UNITED STATES PATENT AND TRADEMARK OFFICE

APPLICATION NO.	FILING DATE	FIRST NAMED INVENTOR	ATTORNEY DOCKET NO.	CONFIRMATION NO.
10/807,311	03/24/2004	Atsushi Yoshimura	04329.3292	3790
22852	7590	06/13/2005	EXAMINER	
FINNEGAN, HENDERSON, FARABOW, GARRETT & DUNNER LLP 901 NEW YORK AVENUE, NW WASHINGTON, DC 20001-4413			DIAZ, JOSE R	
			ART UNIT	PAPER NUMBER
			2815

Office Action Summary	Application No. 10/807,311	Applicant(s) YOSHIMURA, ATSUSHI 	
	Examiner José R. Díaz	Art Unit 2815

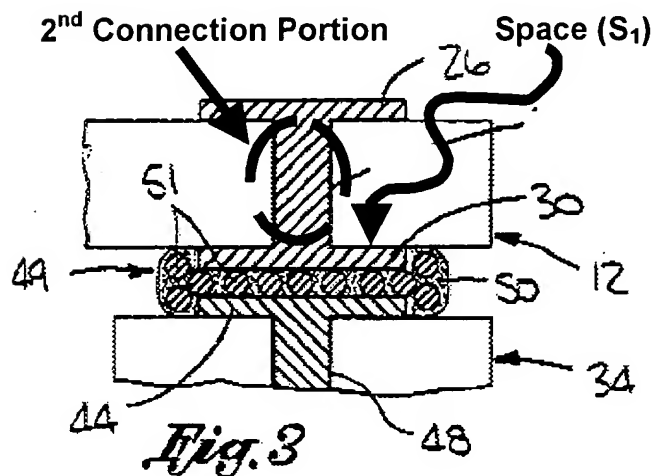
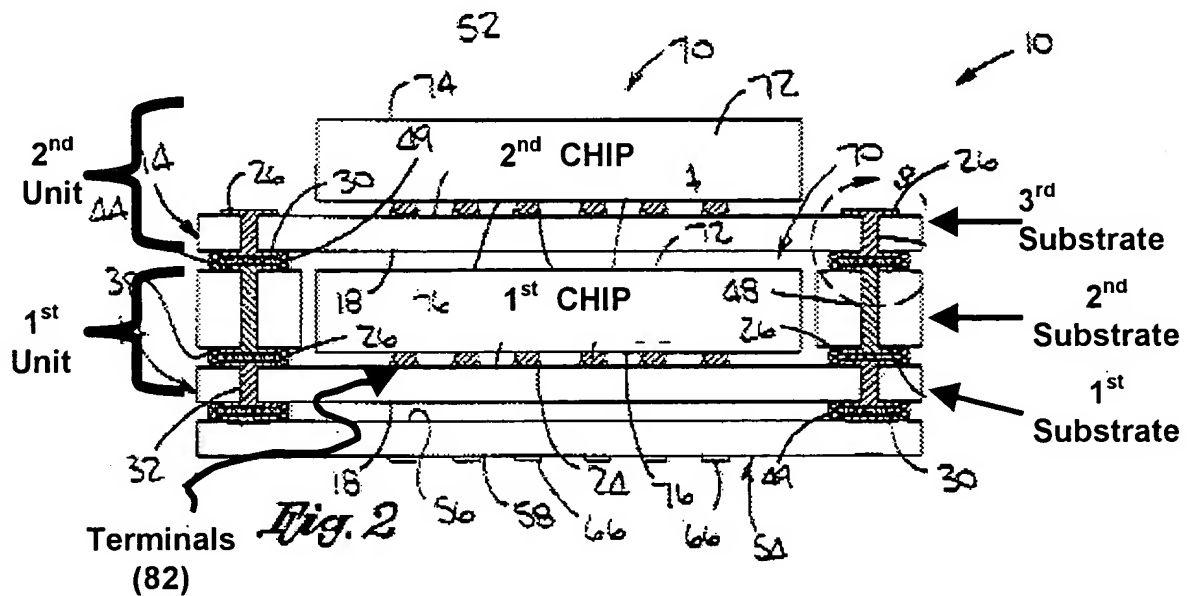
Regarding claim 9, Isaak teaches a semiconductor device comprising:

a first substrate (1st substrate 14) including an integrated circuit chip (1st chip 72) [See figure 2, attached below], first connection terminals (Terminals 82) electrically connected to terminals of the integrated circuit chip (24) [see fig. 2], and a first connection portion (consider through hole 32 formed in 1st substrate 14) spaced from the first connection terminals (Terminals 82) [see fig. 2];

a second substrate (2nd substrate) stacked on the first substrate [see fig. 2, attached below] and including second connection terminals (please consider terminals 51) and a second connection portion (consider 2nd connection portion formed in the 2nd substrate as shown in figure 3, attached below) spaced from the second connection terminals (51) [consider the space S₁ which is formed between the bottom surface of the 2nd connection portion and the upper surface of the second connection 51 shown in fig. 3, attached below]; and

a metal material portion (26) provided between the first connection portion and the second connection portion (fig. 2) and bonding the first connection portion to the second connection portion [please note that portions 30 and 44 of metal 26 are shown bonded with an epoxy component (49 and 50) in figure 3, attached below].

Regarding claim 10, Isaak further teaches a plurality of unit substrates (1st Unit and 2nd Unit as shown in fig. 2, attached above) that are stacked, each of the unit substrates being formed of the first (14) and second (34) substrates stacked (see fig. 2, and col. 8, lines 2-3. Please note that although it is not shown in the figures, Isaak, in col. 8, ll. 2-3, further teaches that an additional second substrate 34 can be provided on the 3rd substrate).

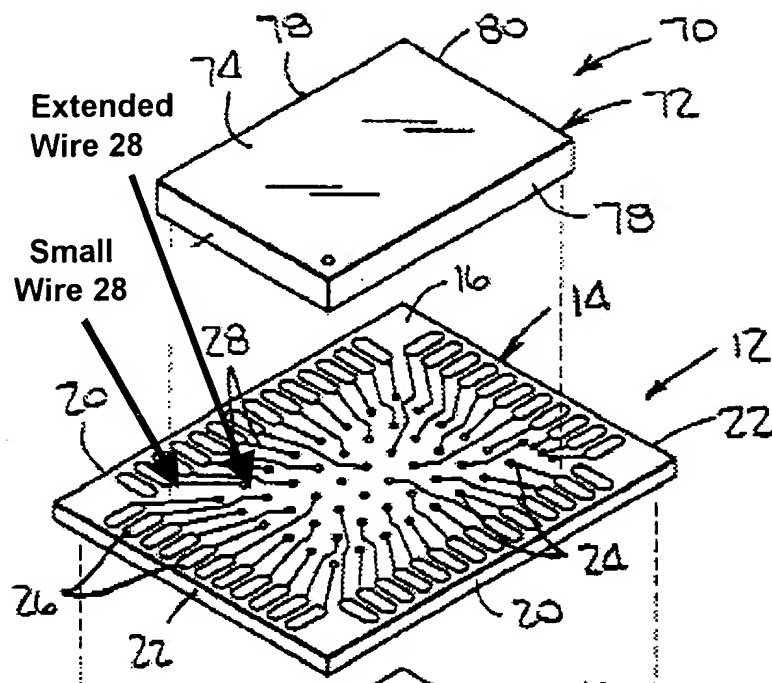
Regarding claim 11, Isaak further teaches an adhesive sheet (49,50) interposed between the unit substrates (1st Unit and 2nd Unit) adjacent each other a stacking direction and bonding the unit substrates together (see figs. 2 and 3, attached above).

Regarding claim 13, Isaak further teaches that the first connection portion is a first dummy pad (30) provided on the first substrate (14) [see fig. 3], and the second connection portion is a second dummy pad (44) provided on the second substrate (34) [see fig. 3].¹
